SERVICE No. 921 BULLETIN

Aileron Inspection

SERVICE No. 1190B BULLETIN

AILERON QUADRANT INSPECTION

Figure 1

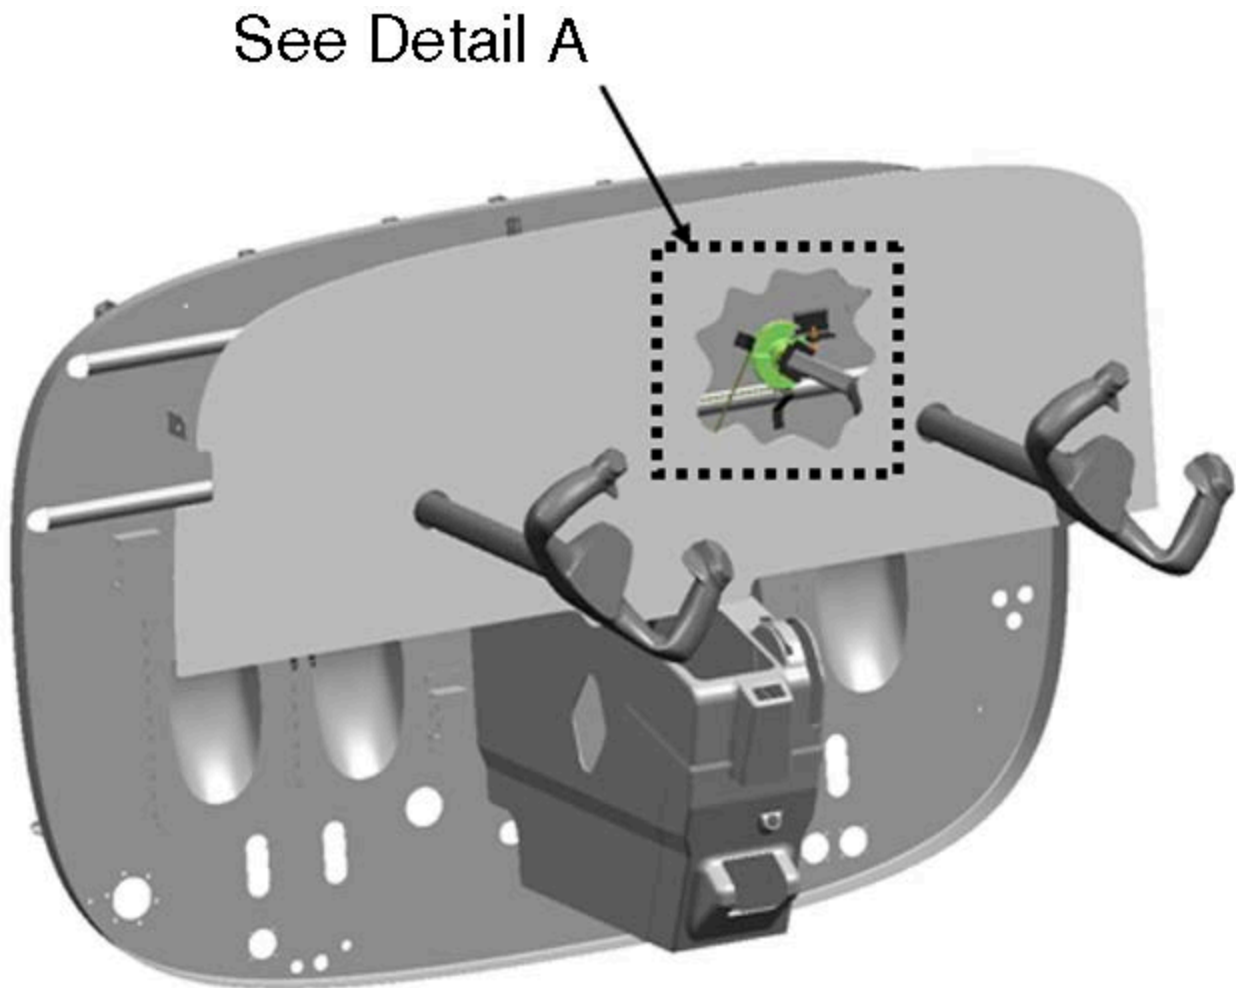
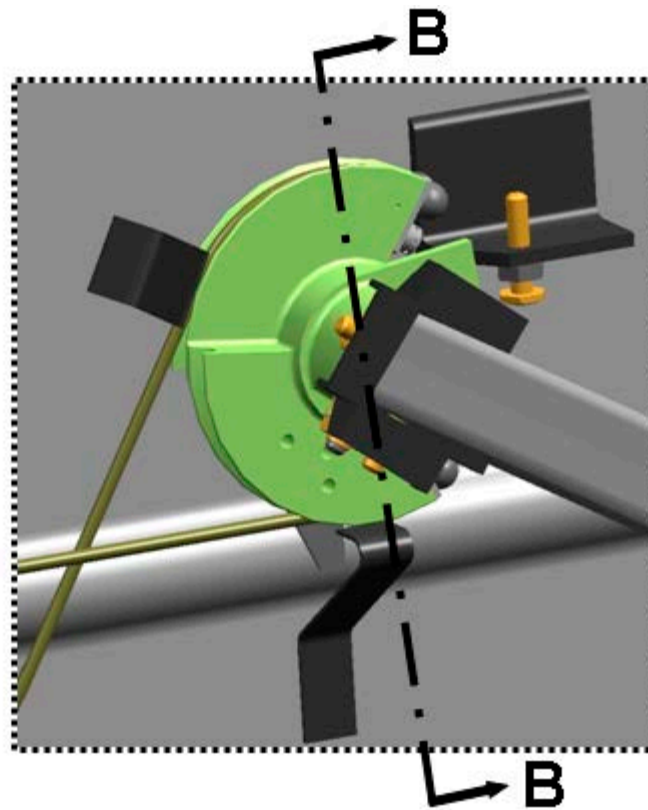
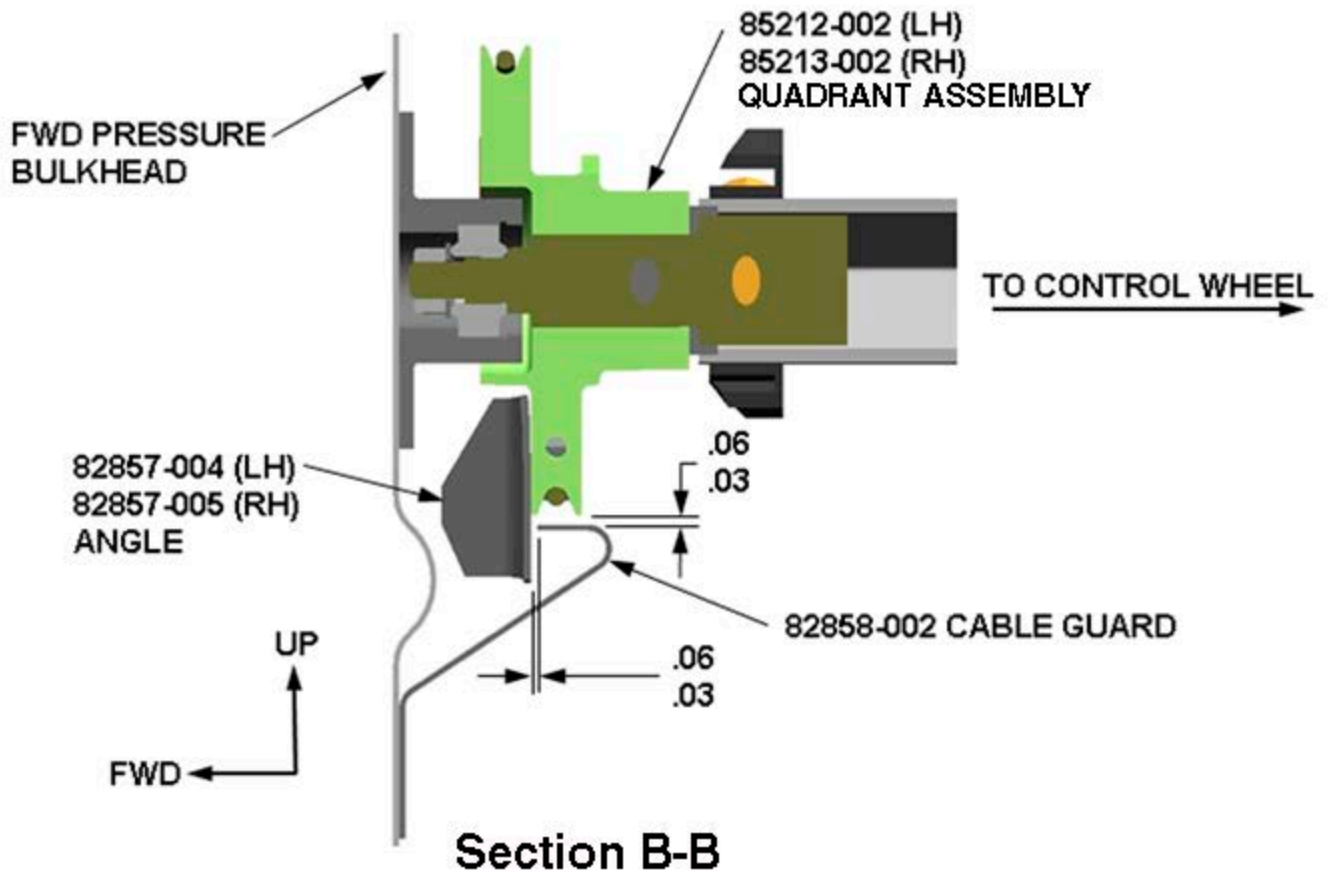
It has been discovered that the cable guards associated with the left and right Aileron Quadrants (located on the aft side of the forward pressure bulkhead) may not ensure positive retention of the aileron control cable for all situations. Left uncorrected, this condition could allow the aileron control cable to move to the opposite side of the cable guard, resulting in roughness and/or friction during roll-control inputs from the control wheel.

1. Locate the Aileron Quadrant Assembly, which is mounted on the aft face of the forward pressure bulkhead, coaxial with the control column tube, both left and right sides. Refer to Figure 1 for clarification (right side shown, left side opposite).
2. Verify that aileron cables are rigged properly, and are nested into the groove of the Aileron Quadrant Assembly (refer to Detail A), in accordance with the standard practices and procedures described in the "Flight Controls" chapter of the Maintenance Manual. Measure clearances between the 82858-002 Cable Guard and the following components: 82857-004 Angle (LH only), 82857-005 Angle (RH only), 85212-002 Aileron Quadrant Assembly (LH only), and 85213-002 (RH only), as shown in SECTION B-B. Rotation of the control wheel will be needed to align the 82857 Angle under the 82858 Cable Guard.

This Service Bulletin provides clearance dimensions between the cable guard and the aileron quadrant, along with instructions for reworking the cable guard, if necessary, to achieve these dimensions.

3. Hand form the 82858-002 Cable Guard, as needed to achieve the clearances shown in SECTION B-B, using a sheet metal bend radius of at least .16 inches (Note: 82858-002 Cable Guard is fabricated from .040 thick 2024-T3 clad aluminum sheet).
4. If the 82858-002 Cable Guard becomes damaged during rework, order and install a replacement Cable Guard. During installation, ensure that clearances conform to SECTION B-B, and install on aft face of forward pressure bulkhead with quantity two (2) NAS1738B rivets (rivet code AAO). Seal rivets in accordance AC 43.13-1B, Change 1, Chapter 6, Section 8.
5. Rotate the control wheels through the full range of travel and verify that there is no roughness and/or friction, binding or chafing. Examine motion of Aileron Quadrant Assembly for proper clearances at all positions.
6. Make a logbook entry indicating compliance with this Service Bulletin.

Figure 1
Aileron Sectors to be Lubricated

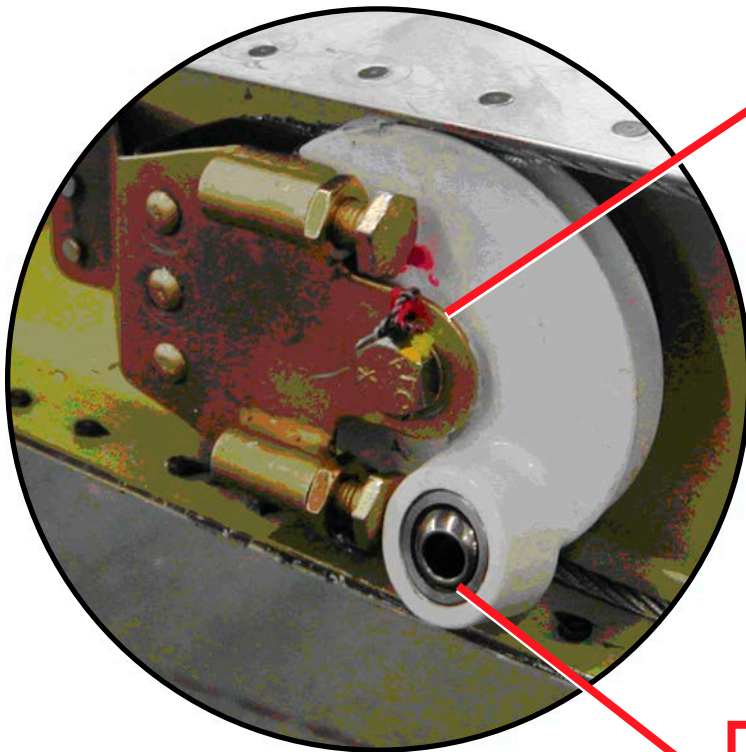
A field report was received of corrosion in an Aileron Sector needle bearing, leading to difficulty of operation during flight. Proper lubrication procedures are critical for prolonging the service life of all aircraft.

Locate both Aileron Sectors, one on each wing, as shown in Figure 1. (See also Lubrication Charts, 12-20-00, of the appropriate maintenance manual.)

1. Clean exterior of Aileron Sector needle bearings with a quick-drying solvent, then apply "LUBRICATING OIL, GENERAL PURPOSE, LOW TEMPERATURE" conforming to MIL-PRF-7870C.
2. Wipe the Self Aligning Bearing area clean of old grease, oil, dirt, etc., then apply "DRY LUBRICANT conforming to MIL-L-60326.

NEEDLE BEARING
Apply Lubricating Oil,
General Purpose, Low
Temperature
conforming to
MIL-PRF-7870C

SELF ALIGNING BEARING
Apply Dry Lubricant
conforming to
MIL-L-60326
